Report Number: ED-23-206

Subject: Staff Report on ED-23-199 - Wentworth Street Reconstruction

Re: **30% Design Review Circulation - Wentworth Street (Regional Road 60)
reconstruction from Cedar Street to Farewell Street (Regional Road 56) in the
City of Oshawa**

Section A: Cedar Street to Nelson Street

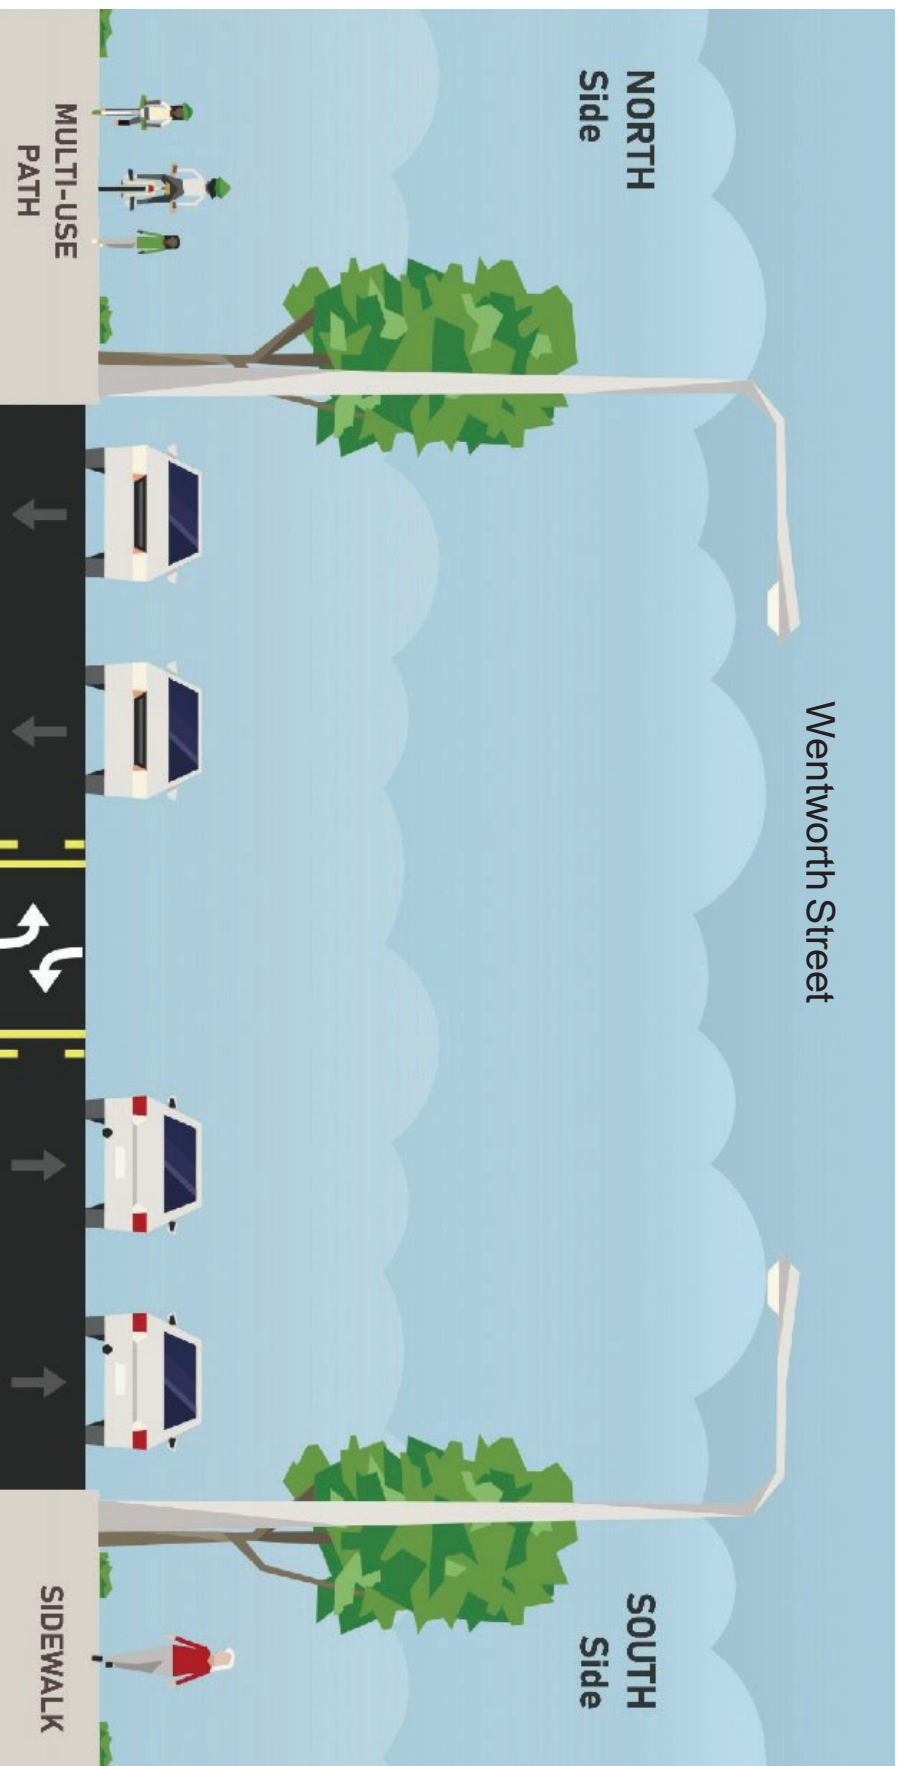
O.A.T.A.C. prefers that Section A end at Ritson Road rather than Nelson Street.

- 4.1 The proposal to reduce the number of traffic lanes from four to two east of Nelson Street is strongly supported. Type “C” arterial roads should be one lane in each direction unless there is a regional scale generator along the road and then the wider road should only be for the section of road needed to accommodate related movements in the vicinity of the traffic generator. The Region should strongly consider reducing the community dividing impact of the four lane section of Wentworth at least from Ritson Road to Farewell Street.

City staff do not support this position for the following reasons:

- The block of land bounded by Ritson Road, Waterloo Street, Nelson Street and Wentworth Street is designated Industrial in the Oshawa Official Plan; and,
- The area generates high volumes of truck traffic from the Consolidated Operations Depot and other uses in the block of land noted above.

Section B: Nelson Street to Farewell Street

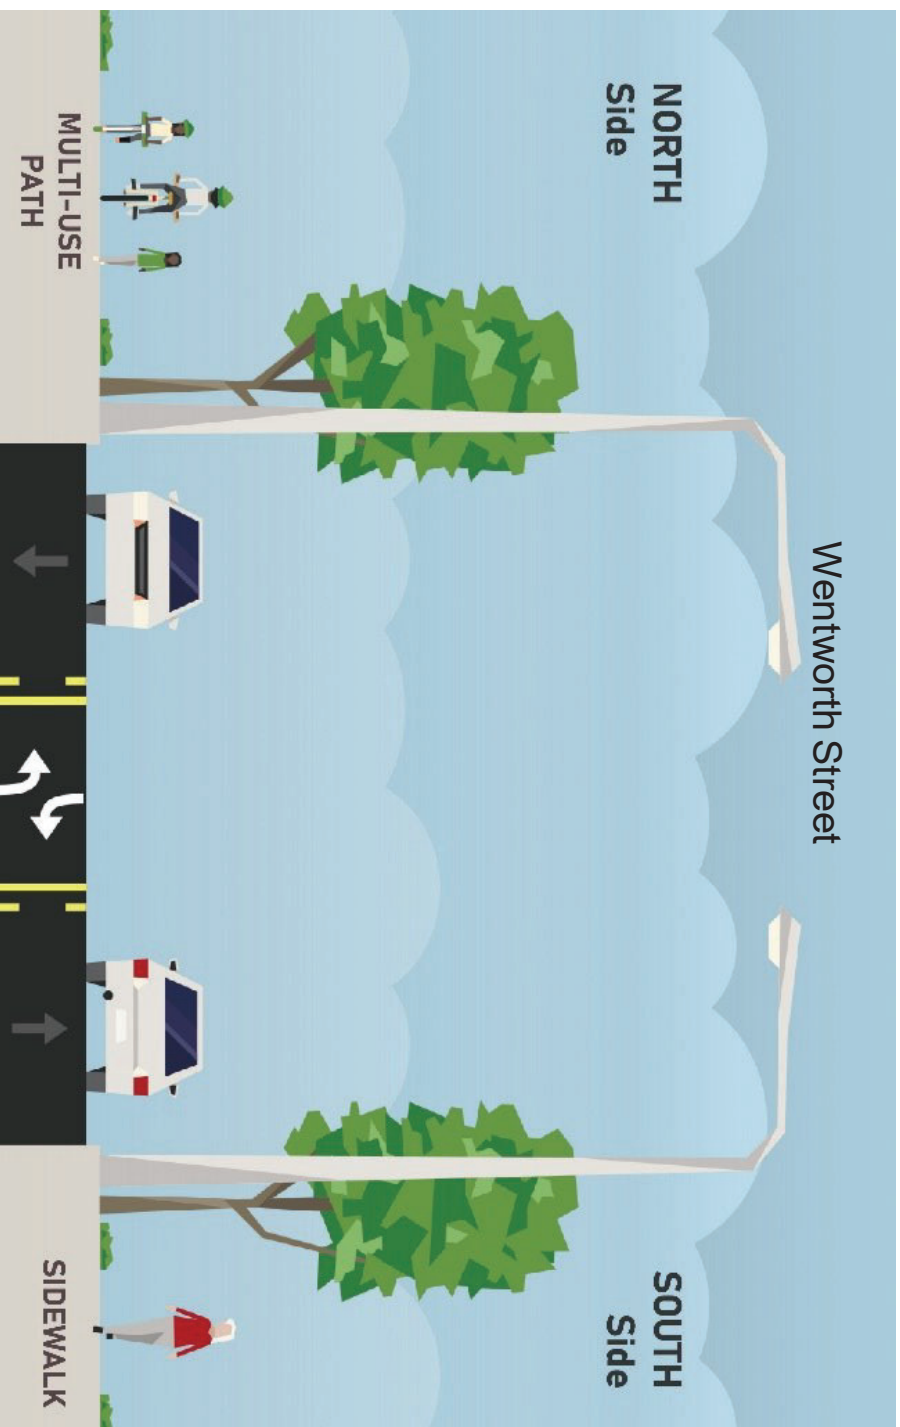
- 4.5 The construction involves significant approaches on intersecting streets such as Simcoe, Ritson, Nelson, Wilson and Farewell. These are all arterial or collector roads. All arterial and collector roads require a boulevard multi-use path on one side and a sidewalk on the other side. It is recommended that the side for each facility be determined now and any re-construction provide a sidewalk on one side and a multi-use path on the other side for the length of the reconstruction

Attachment 1

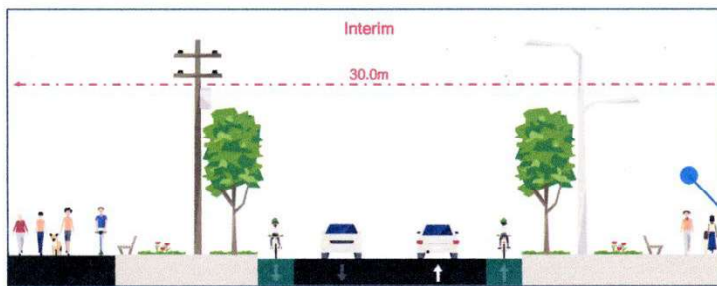
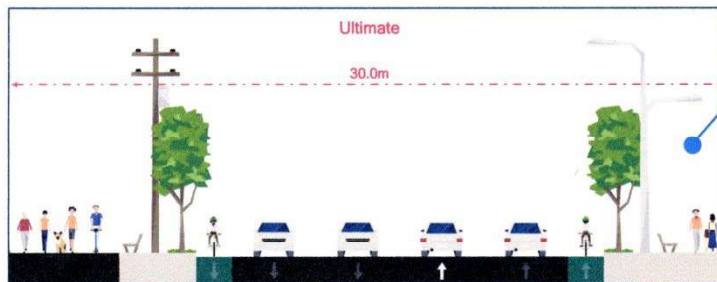
- 4.2 To provide a balanced road system cycle lanes or protected cycle lanes are required as well as the multi-use path on Type “C” arterial road with direct driveway access. A boulevard multi-use path provides beginners going to school or neighbours, for family outings with a safe facility as their speed does not insurmountably conflict with cars backing out of driveways waiting for a break in traffic and watching between the curb only. However experienced cyclists and e-scooters users going quickly to work or other functions would not be seen by drivers as they stop across the multiuse path to observe traffic between the curbs. For a balanced transportation system both facilities are required as shown on the City drawings for Stevenson Road N. Attachment No. 1 (From City of Oshawa Stevenson Road N. EA.)
